288 EAST HASTINGS STREET (COMPLETE APPLICATION)
DE419659 - ZONE DEOD SUB-AREA 1 MAIN/HASTINGS

DEVELOPMENT PERMIT STAFF COMMITTEE MEMBERS

DEVELOPMENT PERMIT STAFF COMMITTEE RECOMMENDATION: APPROVE

Figure 1: 60/40 Unit Breakdown

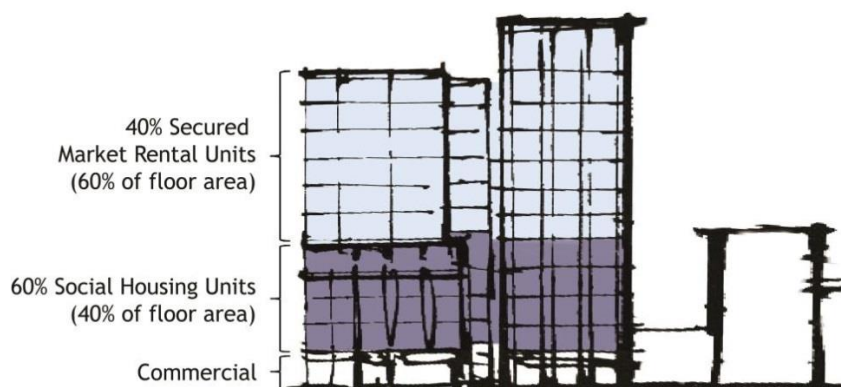
The applicant is providing 104 social housing units (60 %) in just over 40 % of the gross floor area (above 1.0 FSR) and 68 market rental units (40 %) in just below 60 % of the gross floor area (above 1.0 FSR), see figure 1. Market rental units also comprise a portion of the outright 1.0 FSR. Therefore, the application meets this requirement of the DEOD ODP.
